**Before the  
Federal Communications Commission  
Washington, D.C. 20554**

In the Matter of	)	
	)	
Expanding Access to Broadband and	)	GN Docket No. 13-114
Encouraging Innovation through Establishment	)	RM-11640
of an Air-Ground Mobile Broadband	)	
Secondary Service for Passengers Aboard	)	
Aircraft in the 14.0-14.5 GHz Band	)

**REPLY COMMENTS OF THE SATELLITE INDUSTRY ASSOCIATION**

**Figure 1: EIRP Density Limits for Each AMS Ground Station as a Function of Elevation Angle to Protect NGSO Systems (applicable to all azimuth directions)**

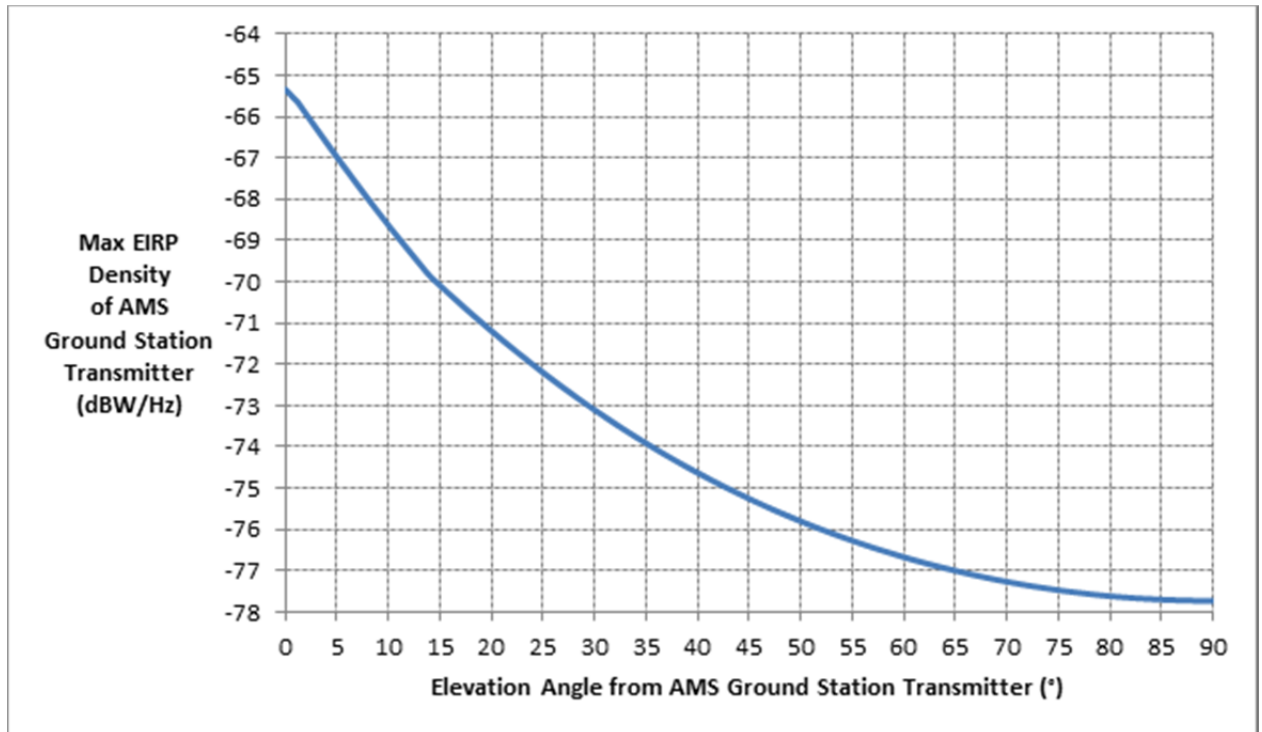
Qualcomm has repeatedly asserted that the “isoflux” antenna of its AMS ground station transmitters will inherently protect NGSO satellites but Qualcomm has not been specific as to what range of elevation angles the antenna is indeed “isoflux” as far as a typical NGSO satellite constellation is concerned. Again in its most recent Comments to the NPRM Qualcomm has made only a vague reference to this.<sup>21</sup> This issue must be addressed in any FCC rule in order to ensure NGSO systems are adequately protected.

In SIA’s Comments to the NPRM an analysis was provided for the case of the AMS ground station appearing at 1 degree elevation angle to the NGSO satellite. For Case C in that analysis the EIRP density of the AMS ground station would need to be limited to -65.59 dBW/Hz at 1 degree elevation. In Figure 1 below this analysis has been extended to all elevation angles and assumed to apply in all azimuth directions. As shown the EIRP density must reduce from approximately -65.4 dBW/Hz at zero elevation to -77.7 dBW at 90 degree elevation. This analysis assumes that, for elevation angles greater than 15 degrees (the assumed minimum operational elevation angle at which the NGSO system provides service), the peak of the NGSO satellite antenna is pointed towards the AMS ground station. A mask such as this must be included in the FCC rules in order to adequately protect primary NGSO satellite systems.
